This letter is in reference to Certificate of Compliance (CoC) No. 9315, for the Model ES-3100 Package, Docket No. 71-9315, USA/9315/B(U)F-96. By letter dated September 6, 2007, the Nuclear Regulatory Commission (NRC) issued Revision 6 of the CoC for the ES-3100. By letter dated October 11, 2007, the Department of Energy (DOE) submitted copies of the Safety Analysis Report (SAR) for the ES-3100 to the NRC, and asked for the review and close out of seven specific items.

A second administrative change is also requested at this time. This change is not related to the seven items referenced above. This request addresses CoC Section 5.(a)(3)(i), Drawing No. M2E801580A037, Sheets 1 through 6. This drawing has been updated and is now Revision B. DOE is asking that the CoC be changed to reflect Revision B, as shown on the marked-up page 2 of the CoC (attached). In creating Revision B of this drawing, the change was to the format of the serial number on the Trefoil data plate. The format had been Y-12-XXXXX; and was changed to XXXXXXXXXX. This allows more flexibility in assigning serial numbers to these containers. Sheet 2 of 6 of the drawing is provided with this letter for information on

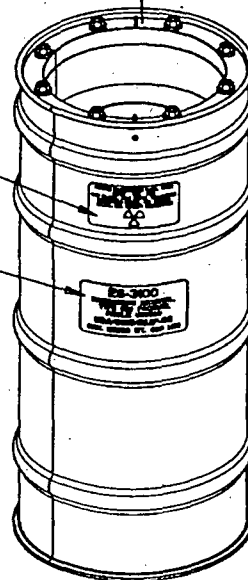
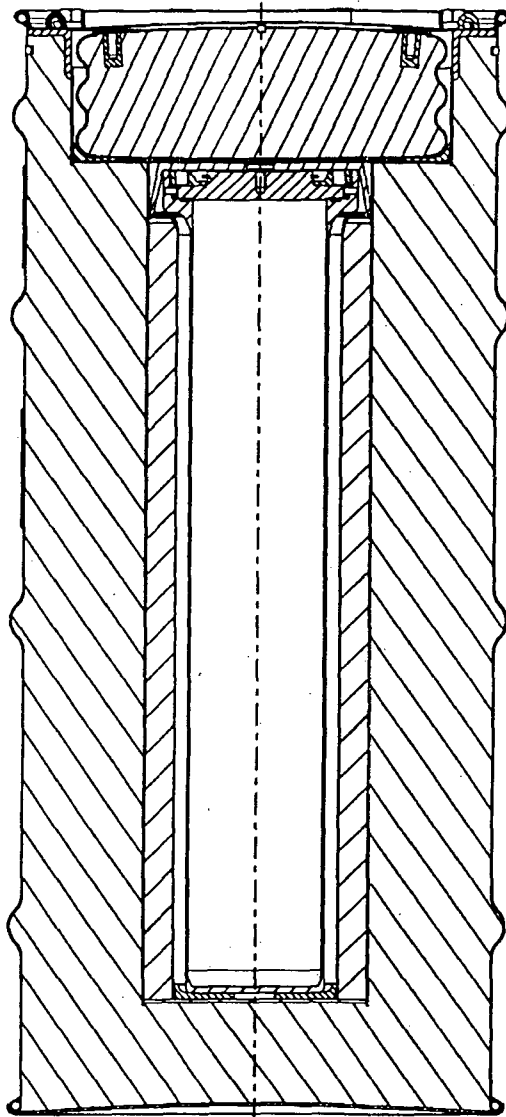
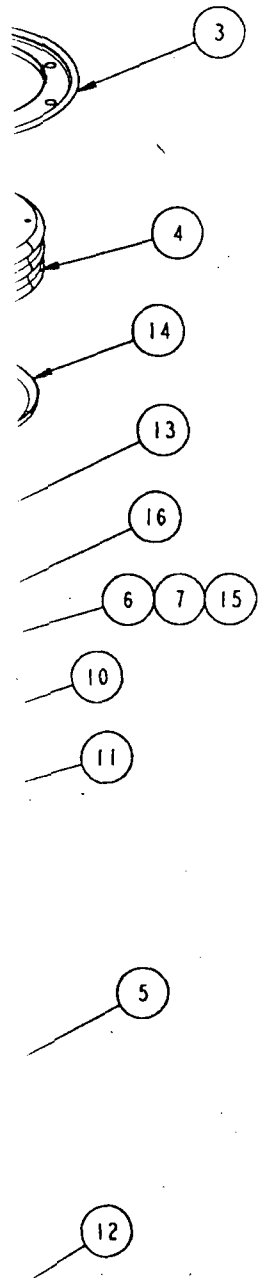
A	B	REVISED TREFOIL DATA PLAT F/N B	JR	JRDA	JR	JG	AB	WIN	MIN	MIN	MIN	MIN	MIN	MIN	MIN	MIN	MIN	MIN	MIN
		PAGE 1: MODIFIED GENERAL NOTES AND UPDATED FIELD NOTES ADDED TOLERANCES TO O-RINGS	RDA	JSL	GAB	JR	JWS	MIN	MIN	MIN	MIN	MIN	MIN	MIN	MIN	MIN	MIN	MIN	MIN
		PAGE 3: ADDED CORRECT TOLERANCES AND REF. DIMS. PAGE 4: ADDED CORRECT INSPECTION DIMS. AND WELD SYMS. PAGE 5: ADDED CORRECT TOLERANCES AND INSPECTION DIMS. AND ADDED NOTE TO -5 ADDED SHEET 6 RN Y2003-0328	FOR	MIN	MIN	MIN	MIN	MIN	MIN	MIN	MIN	MIN	MIN	MIN	MIN	MIN	MIN	MIN	MIN
O	RN: Y2003-0328 ORIGINAL ISSUE	JMR	GM	GAB	RBC	MLG	MIN	RDA	MIN	JG	MIN	MIN	MIN	MIN	MIN	MIN	MIN	MIN	
REV	DESCRIPTION	BY	CHKD	DATE	BY	CHKD	DATE	BY	CHKD	DATE	BY	CHKD	DATE	BY	CHKD	DATE	BY	CHKD	
		REVISION OR ISSUE PURPOSE										REVISION APPROVALS
